Comments on Draft Safety Evaluation for ANP-10323, Revision 0 Supplement 1P, Revision 0, "One GALILEO Fuel Rod Thermal-Mechanical Methodology for Pressurized Water Reactors."

U. S. NUCLEAR REGULATORY COMMISSION
DRAFT SAFETY EVALUATION
FOR FRAMATOME INC. TOPICAL REPORT
ANP-10323 REVISION 1, SUPPLEMENT 1P, REVISION 0,
“ONE GALILEO FUEL ROD THERMAL-MECHANICAL METHODOLOGY FOR
PRESSURIZED WATER REACTORS”
DOCKET NO. 99902041
EPID: L-2025-TOP-0015

Figure 1: Power history and axial power shapes assumed for NRC sensitivity study

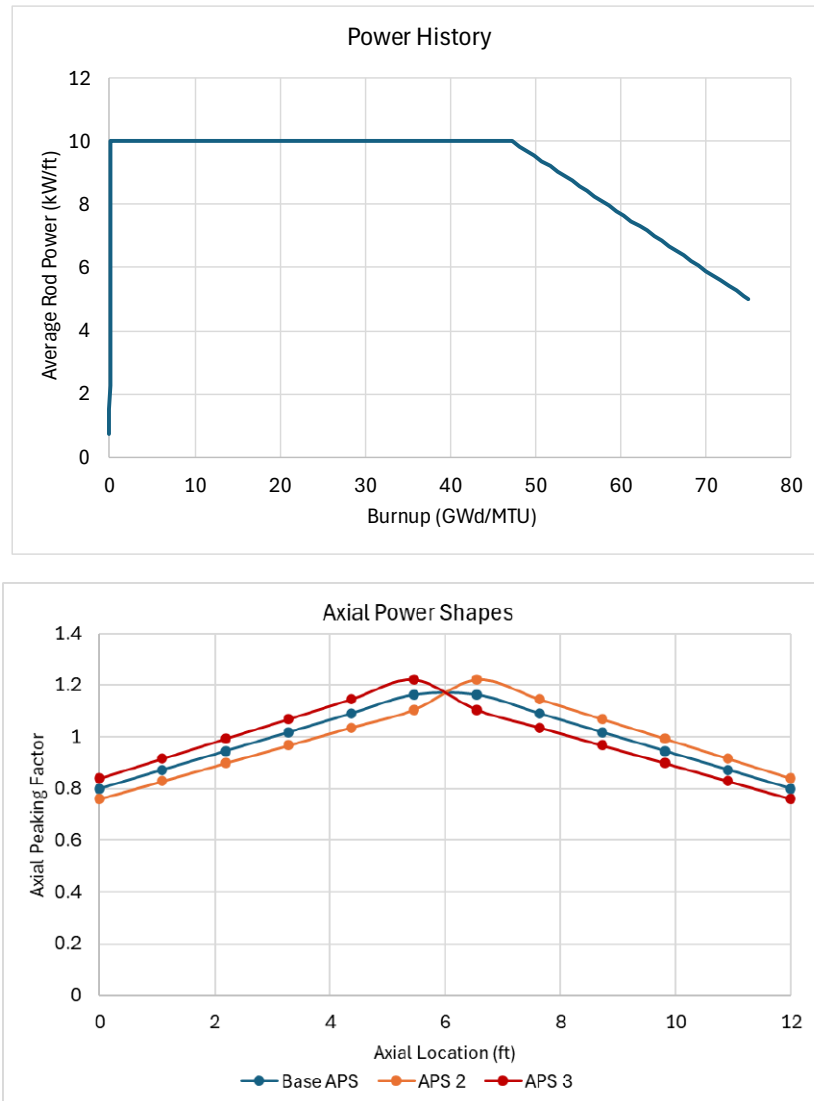
Similarly, for the oxide thickness, **[[**
]]The NRC staff conducted sensitivity studies with the Fuel Analysis under Steady-state and Transients (FAST) fuel performance code (Ref. 8), to verify **[[**
]] The NRC staff applied uncertainties similar to those in Reference 3. **[[**

Figure 2: NRC APS sensitivity study results as function of burnup for RIP (top) and oxide thickness (bottom)

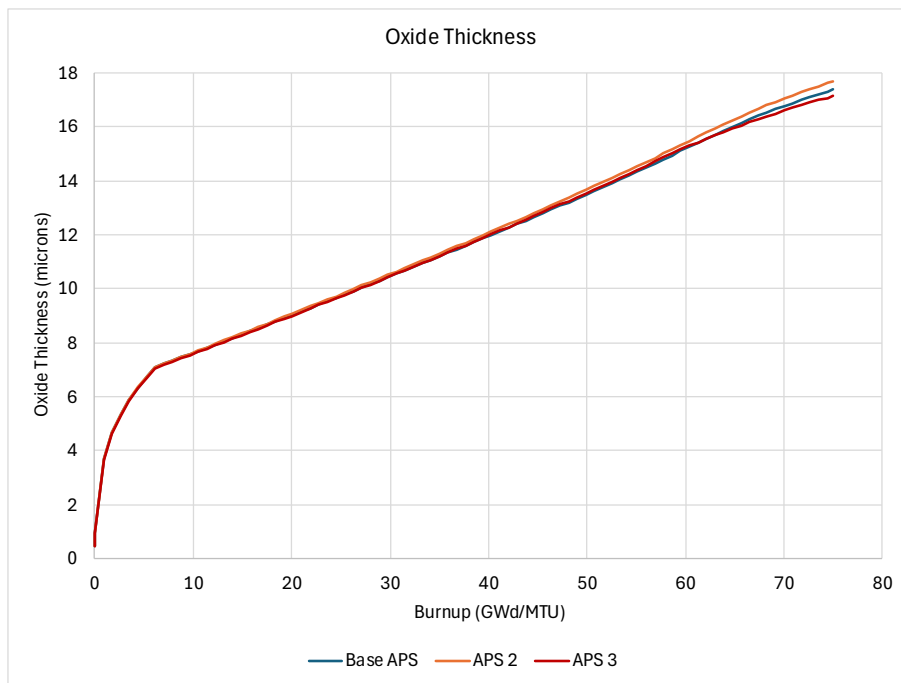
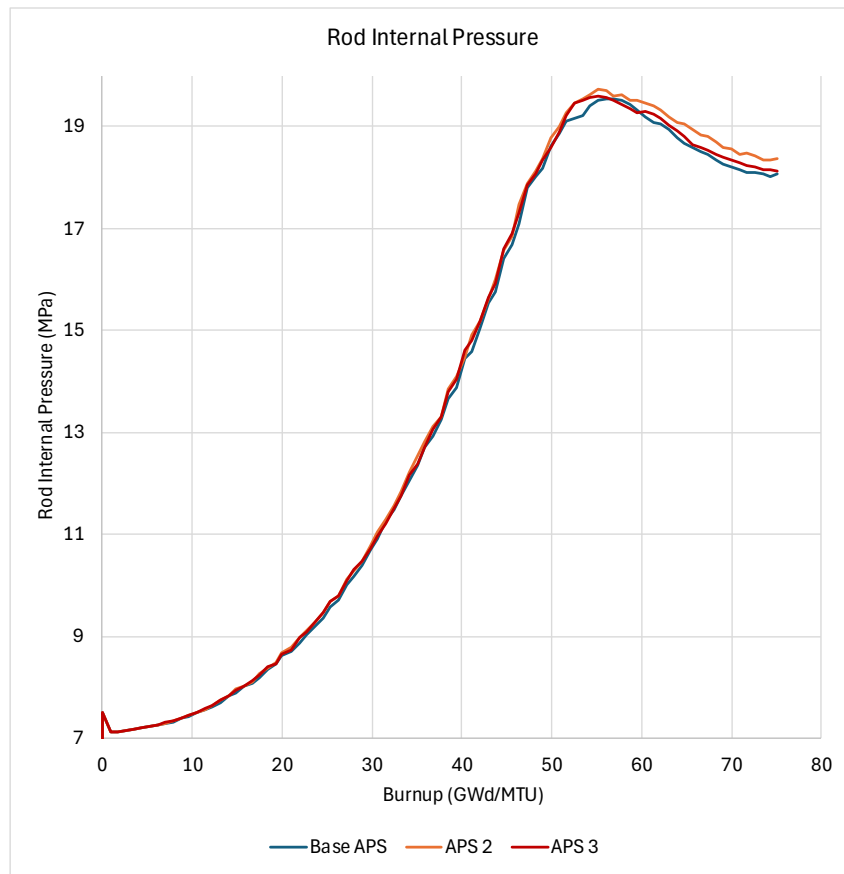
The NRC sensitivity study results above show that for the case that the NRC staff analyzed, had a negligible effect on RIP and oxide thickness, helping to confirm Framatome’s assertion and sensitivity study. The NRC staff notes that for some other FAST cases not reported above with more top peaked APSs and/or larger uncertainties, a larger impact was observed on RIP and oxide thickness. Despite this, the NRC finds Framatome’s treatment of to be acceptable because the uncertainties of ARCADIA (Ref. 6) are expected to be in line with the sensitivity study, and a top peaked APS is not expected to occur for the entirety of rod’s residence time in the reactor as the NRC assumed in the simple FAST exploratory runs. Therefore, the NRC staff finds the treatment to be acceptable because it is not expected to have a large impact on RIP and oxide thickness.
